To: T10 Technical Committee
From: Barry Olawsky, HP (barry.olawsky@hp.com)
Date: 13 January 2005
Subject: T10/05-025r1 SFF8470 Crosstalk Study

Provide technical data (electrical) to evaluate the feasibility of proposal 05-007r0. Specifically, demonstrate crosstalk summation and provide analysis to support necessary changes.

SFF8470 Crosstalk Study

Review of 05-007r0

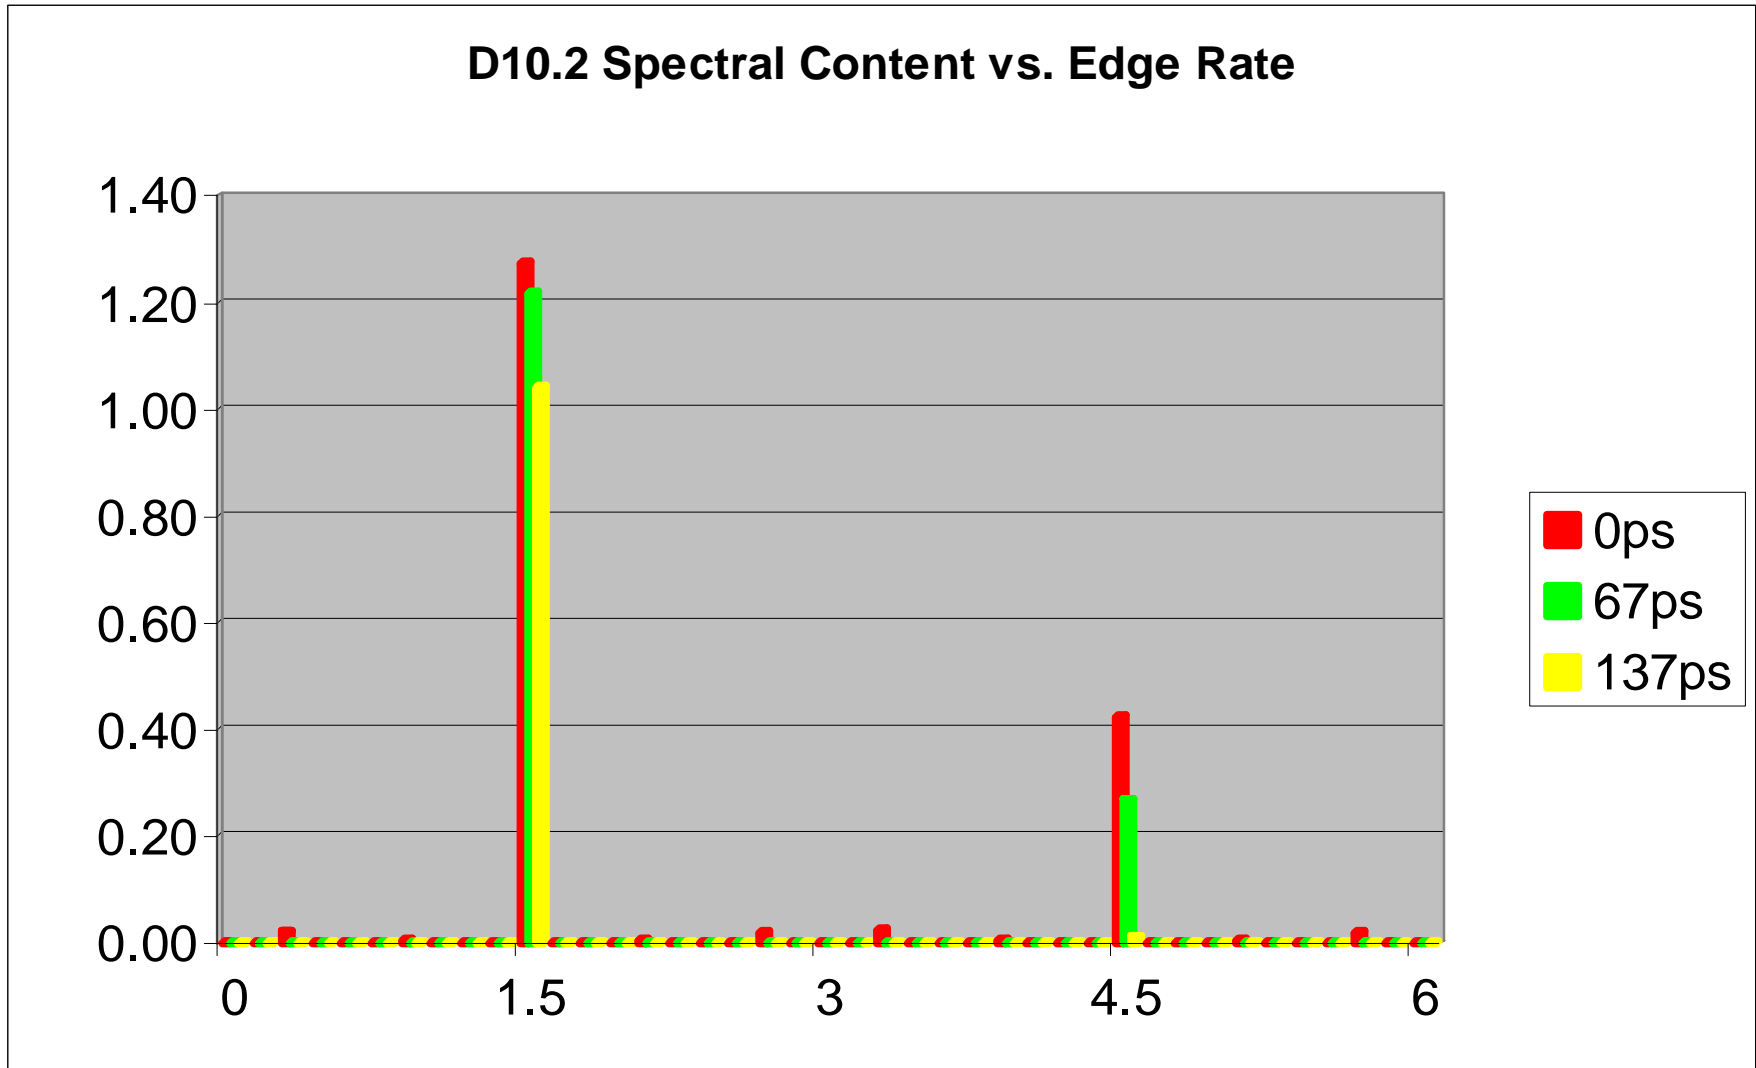
- Proposal specifies NEXT of -30dB (3.2%) for single pair from 10 to 4500MHz.
- Combining crosstalk from different pairs could yield value that is much larger than 5%.
- Previous sample measurements have demonstrated NEXT amplitudes in excess of 3.2% above 2GHz for most samples tested.

Proposed Changes to 05-007r0

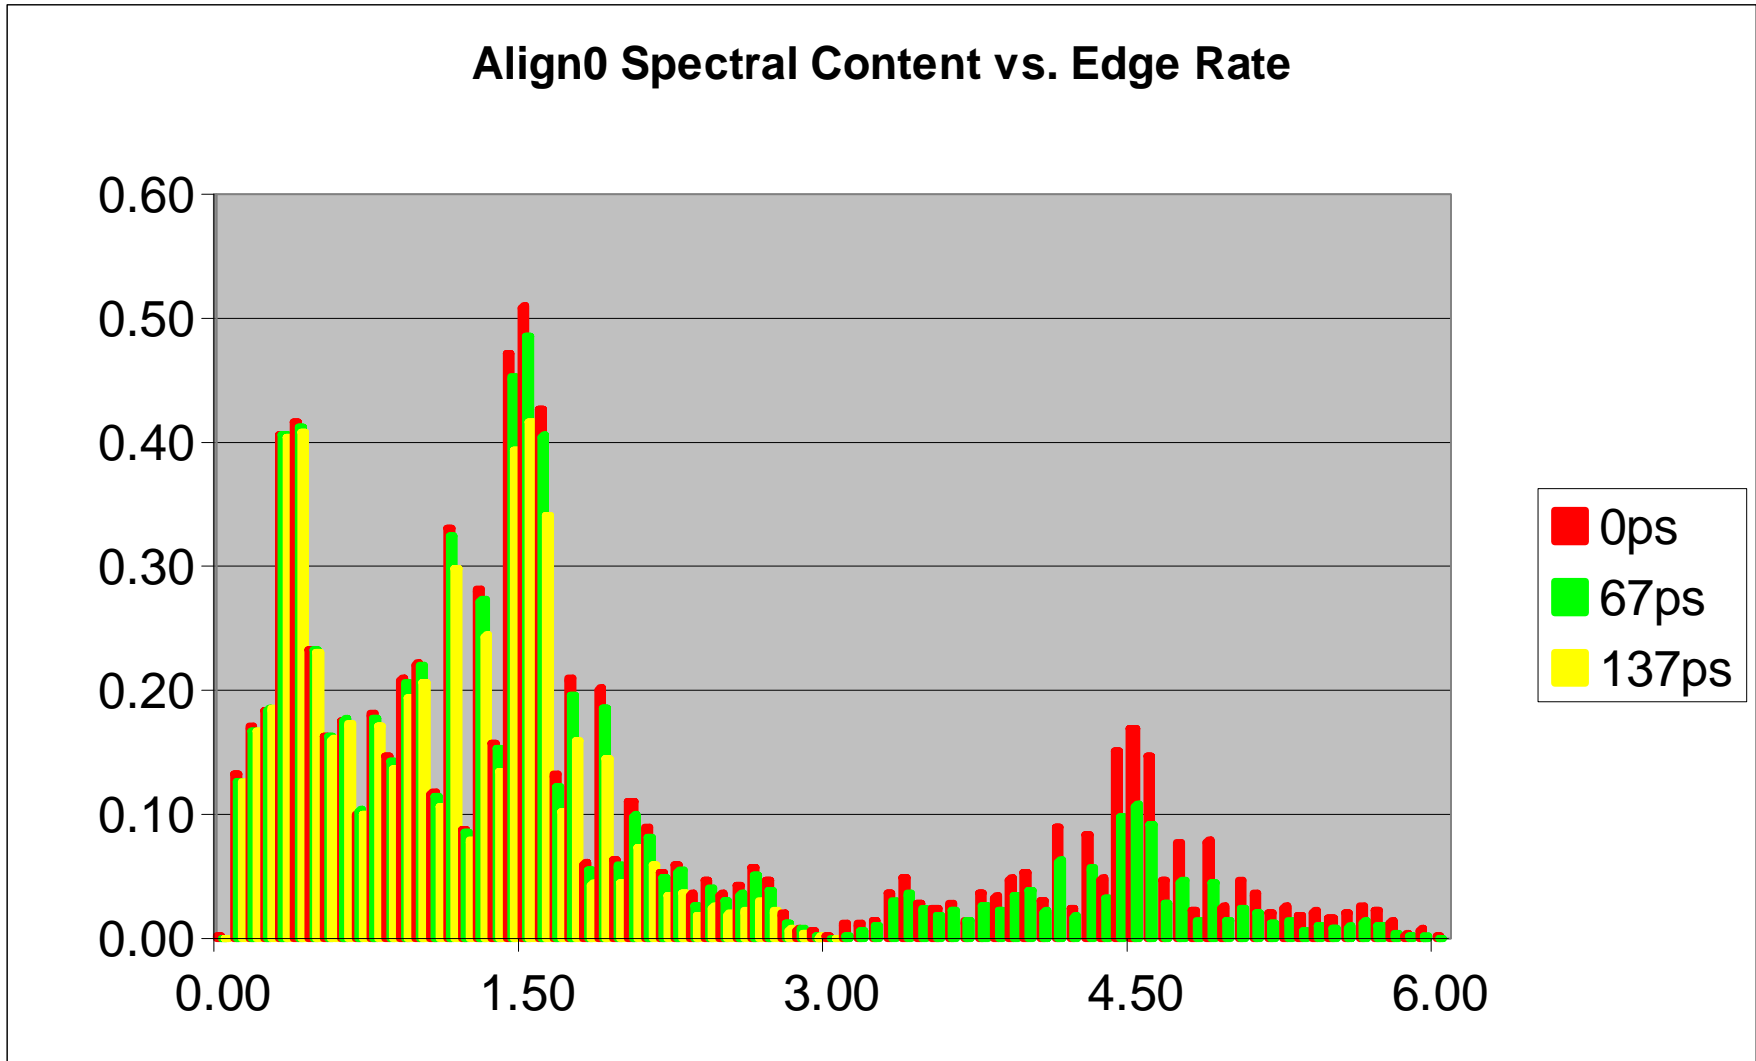
- Consider reducing allowable crosstalk at fundamental such that multi-aggressor sum is less than or near 5%
- Crosstalk isolation required above the fundamental may possibly be reduced. Crosstalk of energy at harmonics must be appropriately accounted for in crosstalk budgeting.
